#2014-60
Murphy's Oil Fuel Station – Special Use Permit, Final PUD Amendment and Plat of Subdivision Project Review for Planning and Zoning Commission

Meeting Date:	May 20, 2015
Requests:	Special Use Permit, Final PUD Amendment and Final Plat of Subdivision for a Murphy's Oil fuel station.
Location:	1205 S. Route 31
Acreage:	Approximately 1.06 acres
Zoning:	B-2 PUD General Commercial
Surrounding Properties:	North: B-2 PUD General Commercial (Goodwill and Pauly Toyota) South: B-2 PUD General Commercial (Wal-Mart) East: B-2 PUD General Commercial (Wal-Mart) West: E-5 Estate (Barn Nursery)
Staff Contact:	Elizabeth Maxwell (815.356.3615)

Left Elevation Detail

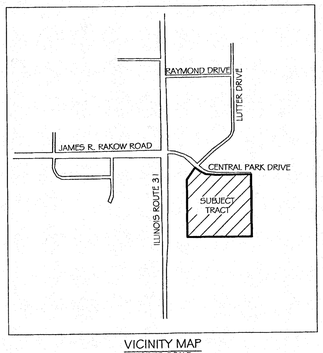
3. Elevations
   a. The building elevation shall be revised so that the stand-alone window bay does not go to the ground, but that the brick base continues through that area on both the left and right elevations.

PRELIMINARY PLAT
WAL-MART COMMERCIAL SUBDIVISION

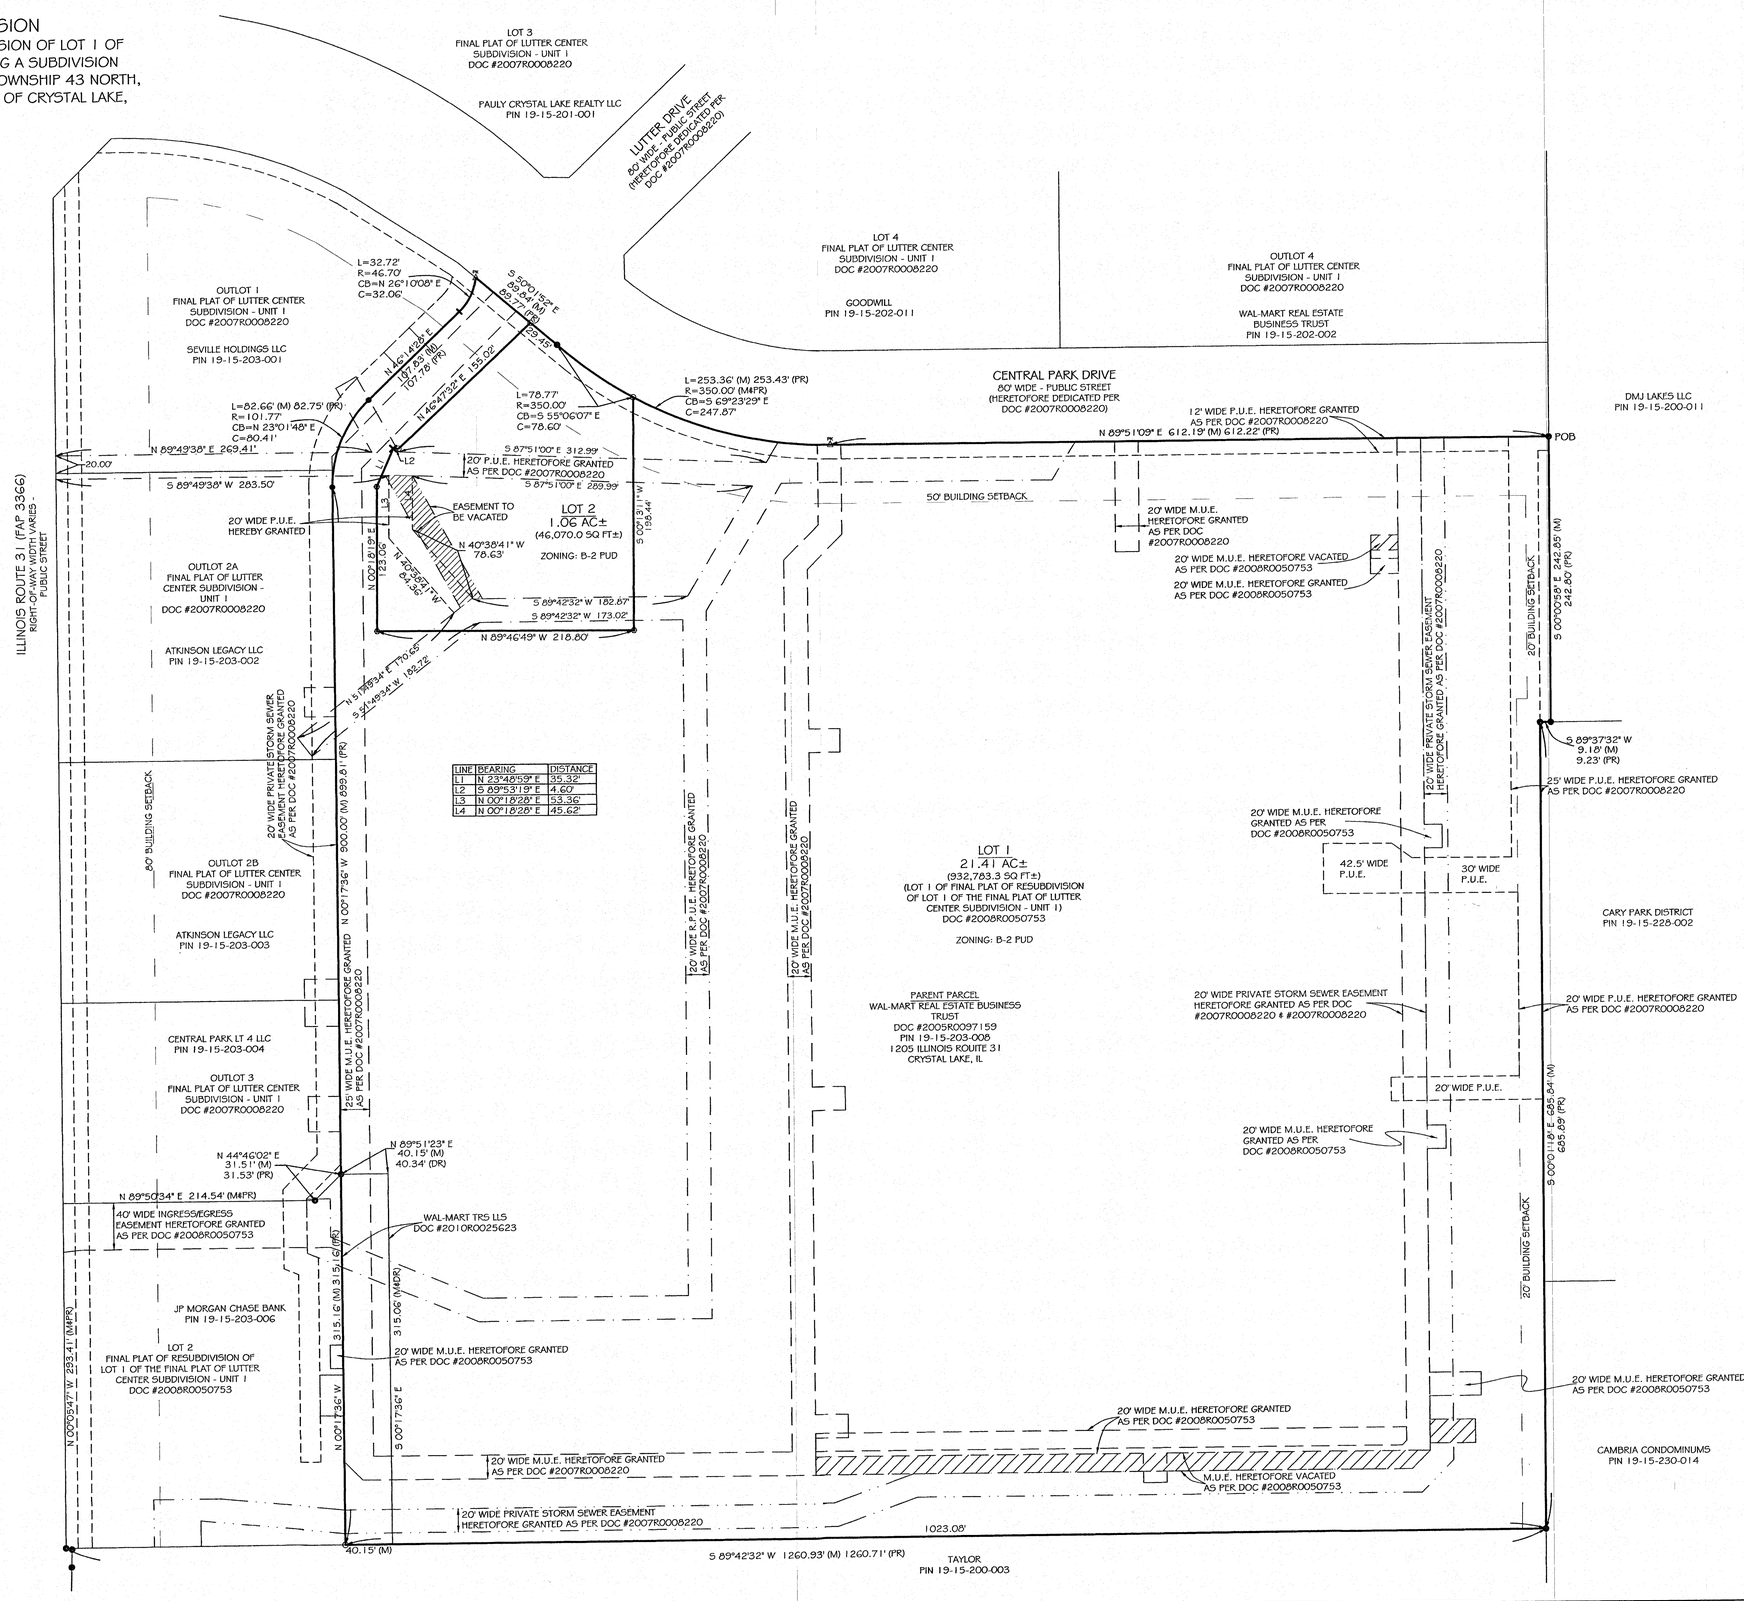
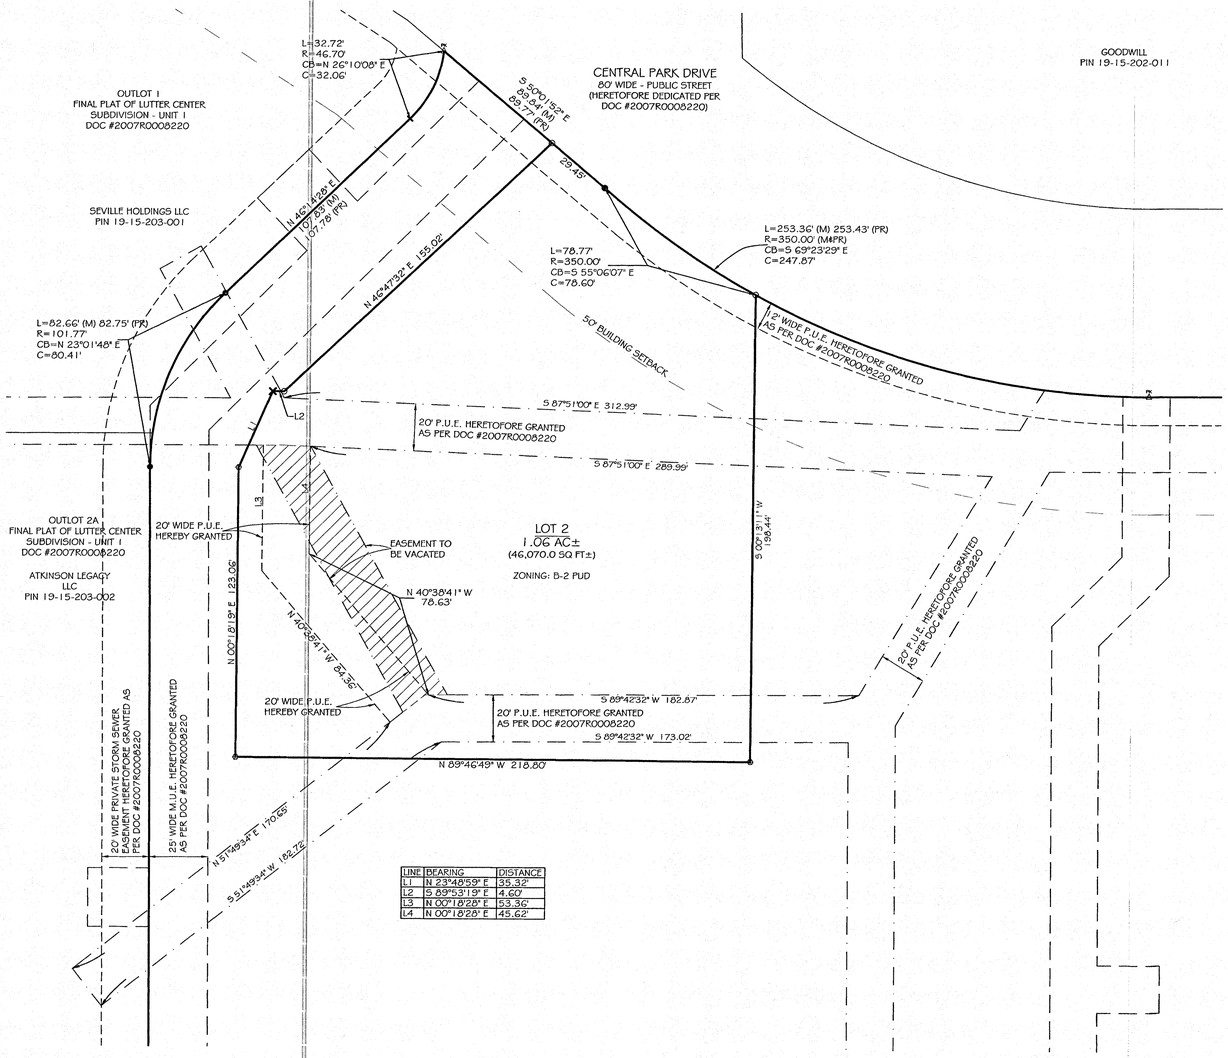
4. Plat of Subdivision
   a. Amend the plat title to read Final Plat.
   b. Remove the IDOT signature block from the plat.
   c. A revised final plat shall be provided to the City with Owner, County Clerk and Surveyor/Surface Water Drainage certificates signed.
